# SITE DEVELOPMENT PLAN FOR SECURITY WATER DISTRICT WATER TREATMENT PLANT BUILDING ADDITION

EPC PCD FILE PPR262

**SWD PROPERTY SITE PLAN**  
WATER TREATMENT PLANT BUILDING ADDITION  
SECURITY WATER DISTRICT

**SITE GRADING, DRAINAGE, LANDSCAPING, AND EROSION CONTROL PLAN**  
WATER TREATMENT PLANT BUILDING ADDITION  
SECURITY WATER DISTRICT

**BUILDING SITE PLAN**  
WATER TREATMENT PLANT BUILDING ADDITION  
SECURITY WATER DISTRICT

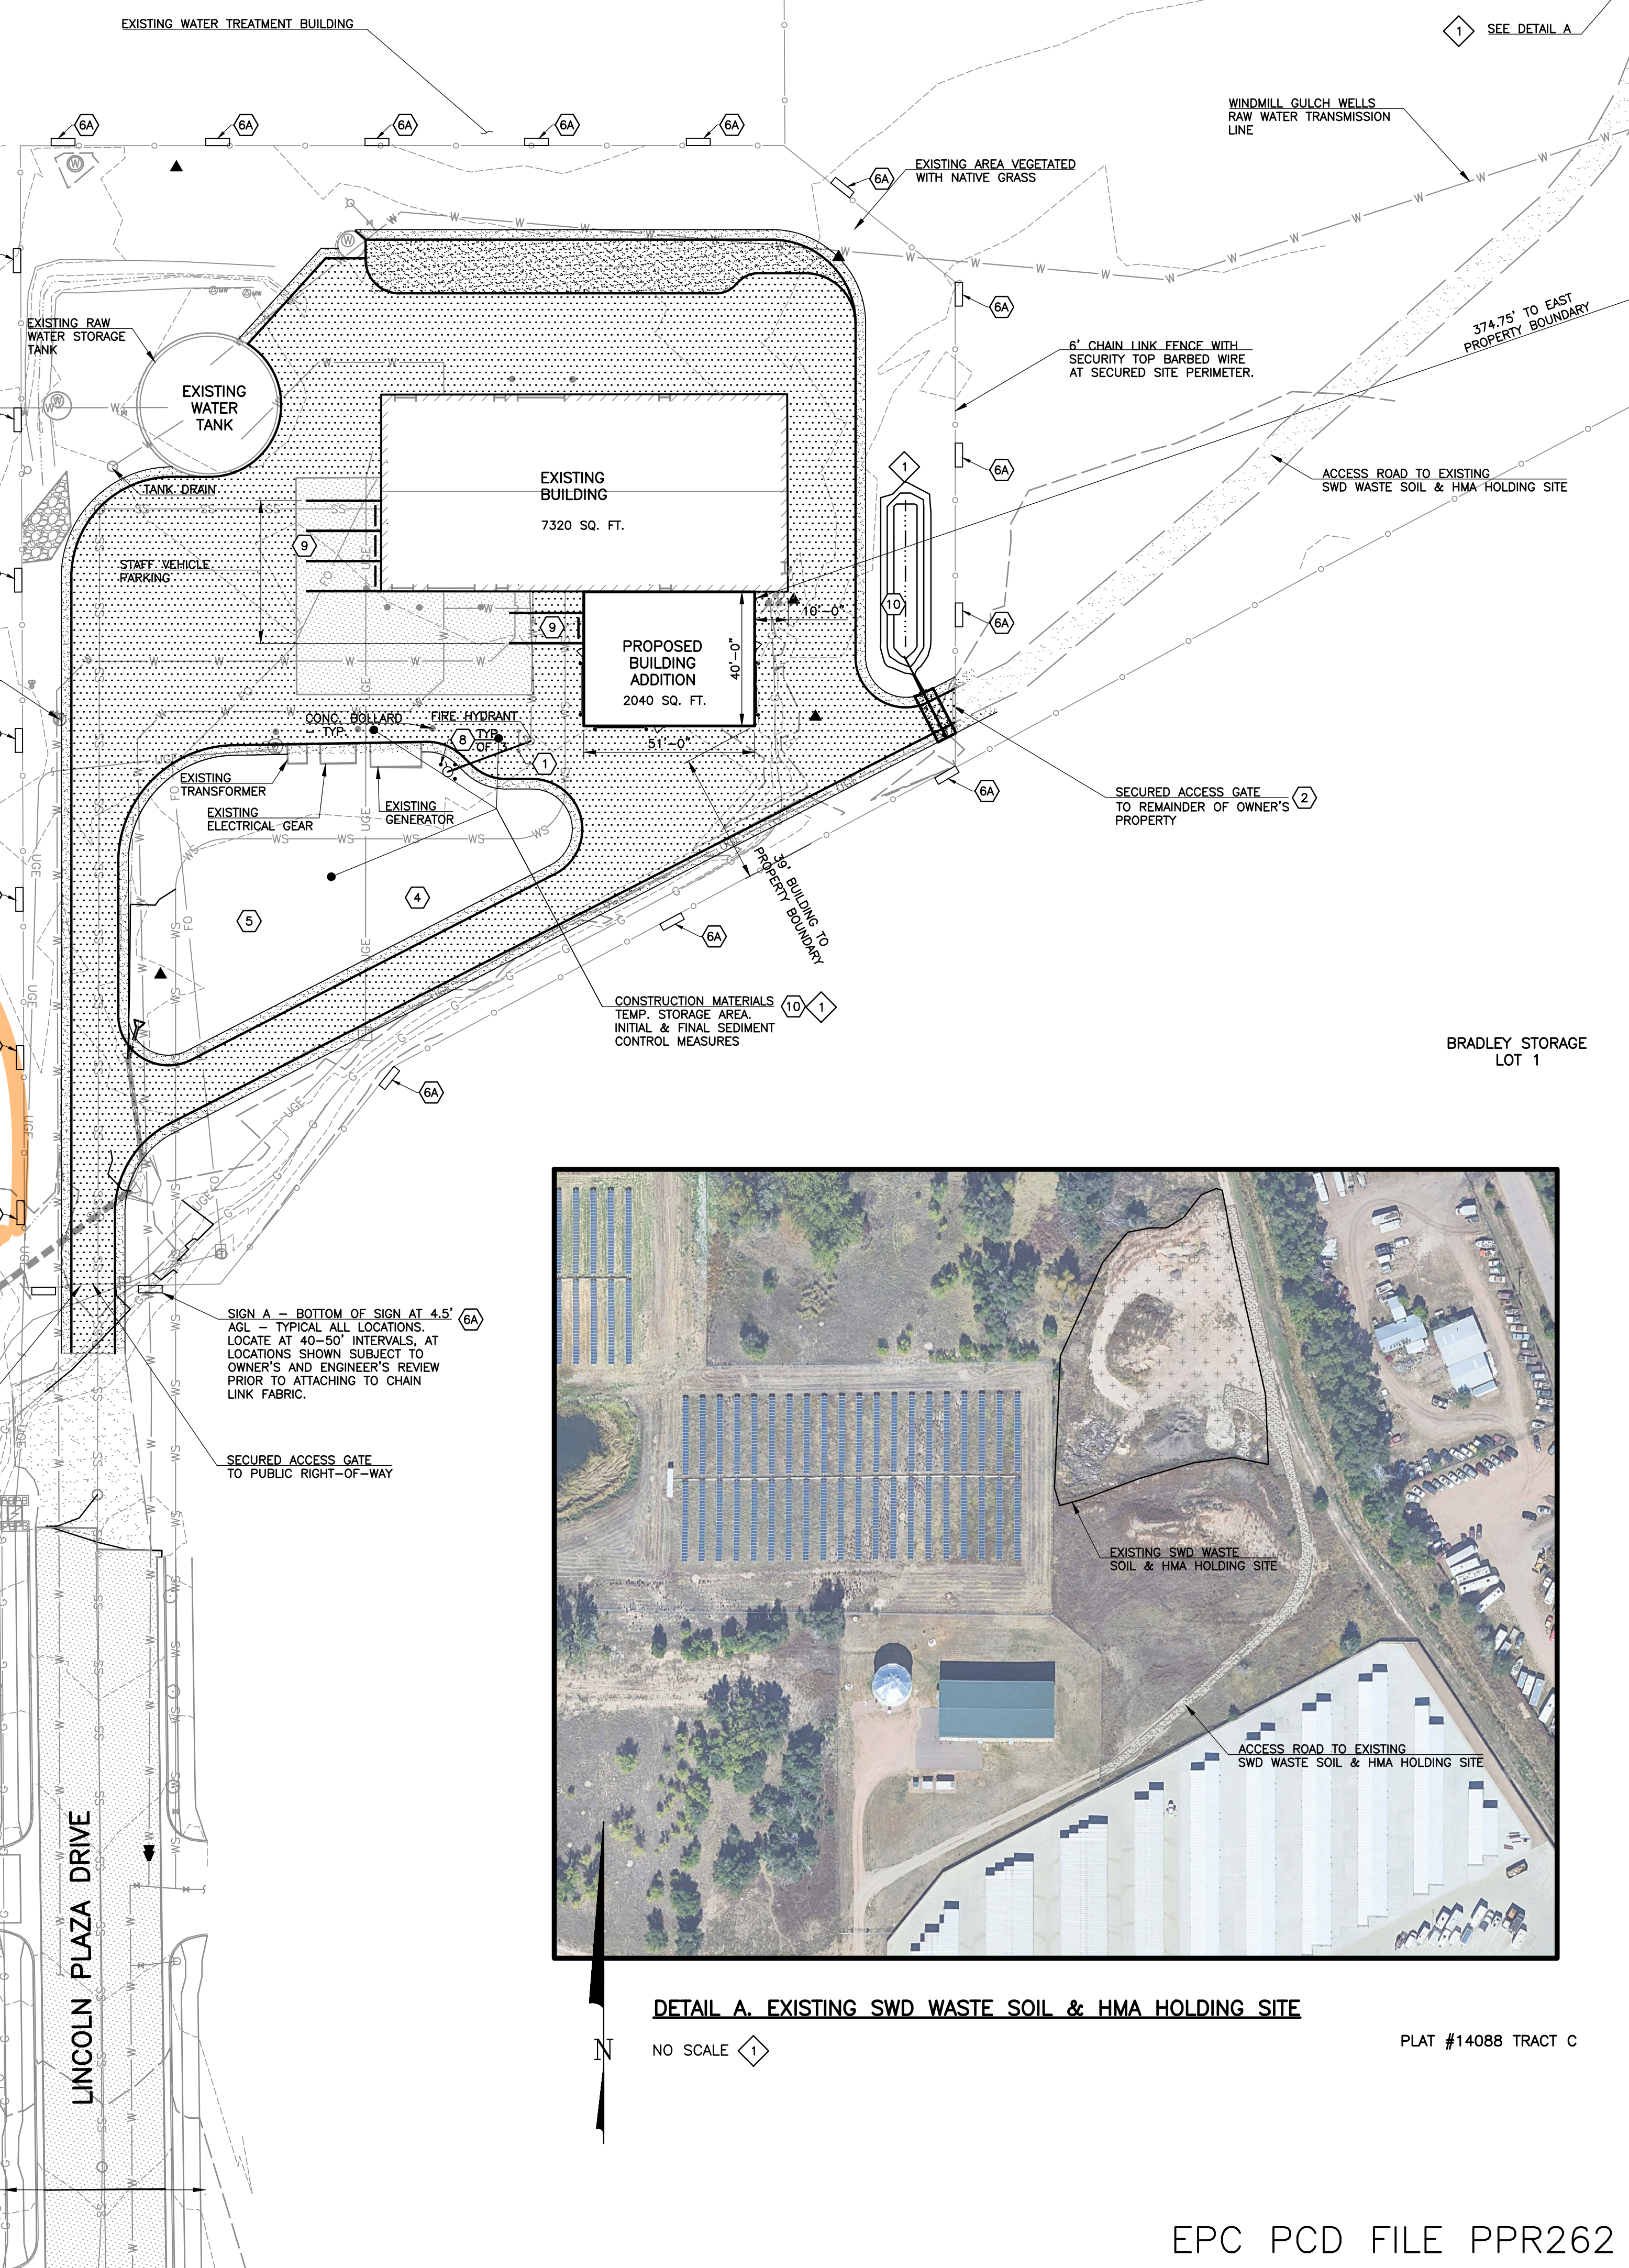
Please show all drainage improvements on the site development plan

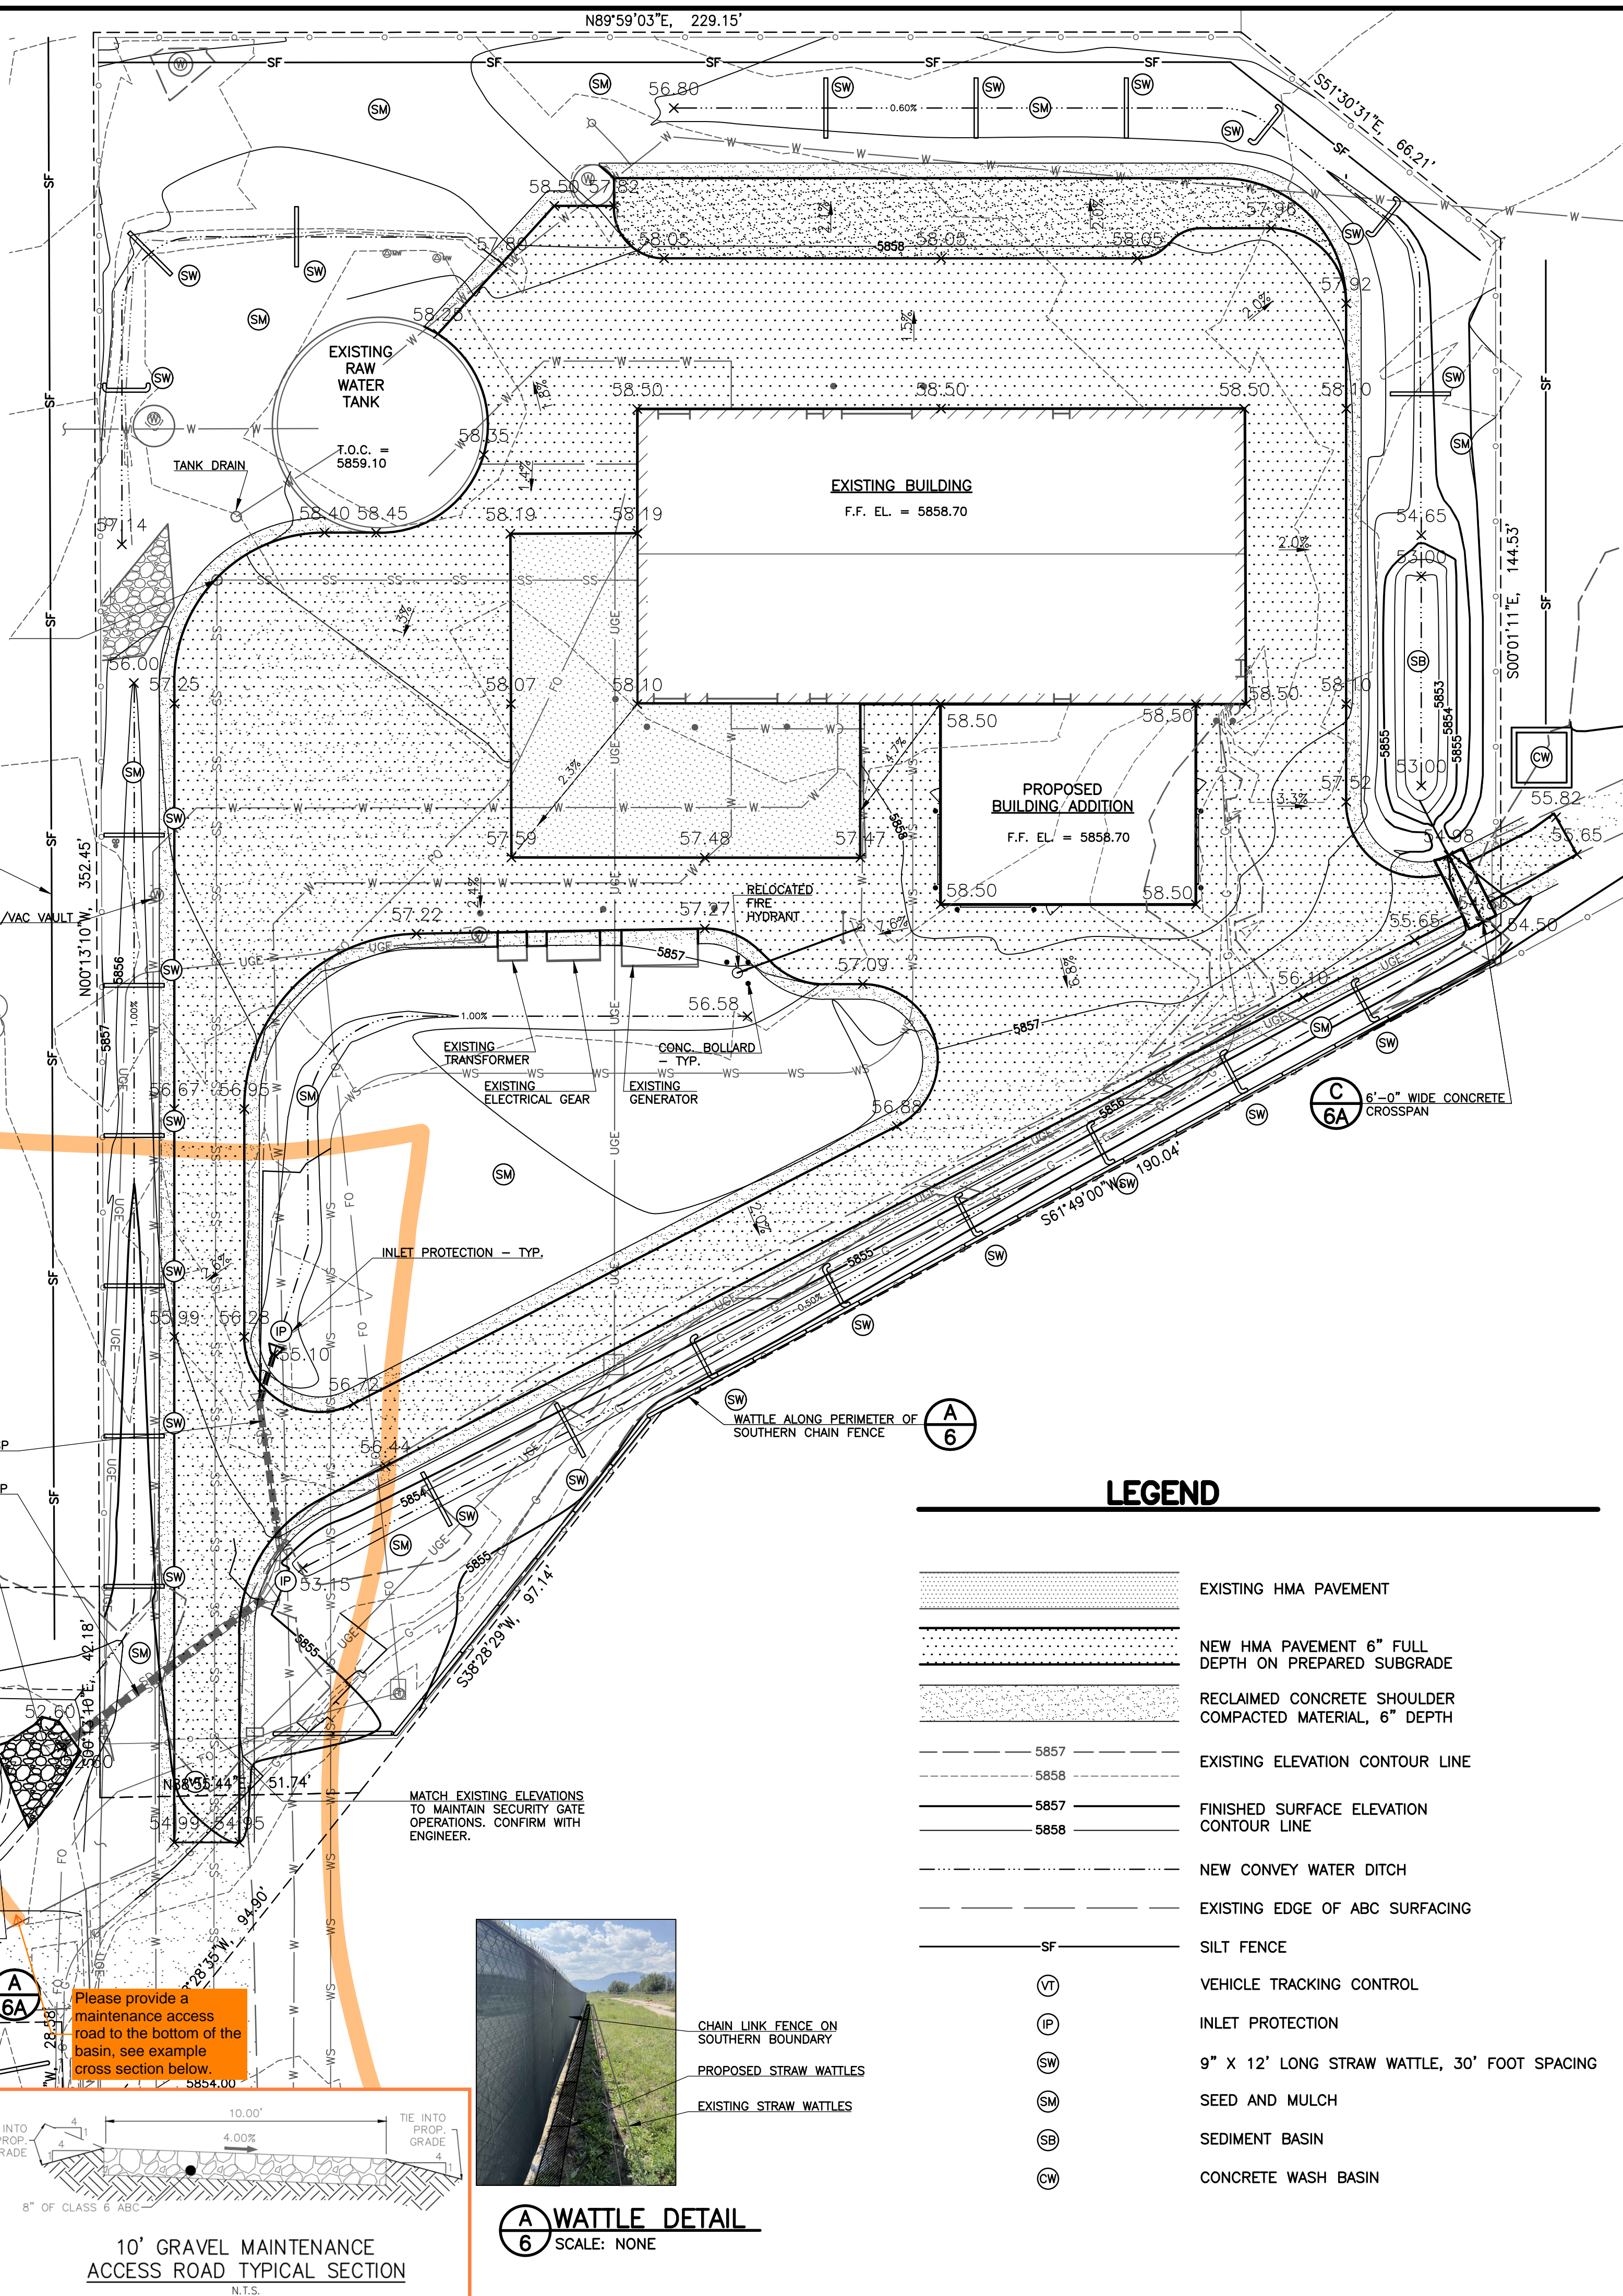
Provide this sheet (or just the area in the orange box) in the GEC plan, where the design is approved by the engineering department

Assign a name/number to all PCMs and then update all submitted text and drawings accordingly with consistent labeling throughout (example: "Pond A" or "Pond 1").

Provide callout for end cap and orifice hole of outlet pipe

Please provide a maintenance access road to the bottom of the basin, see example cross section below.
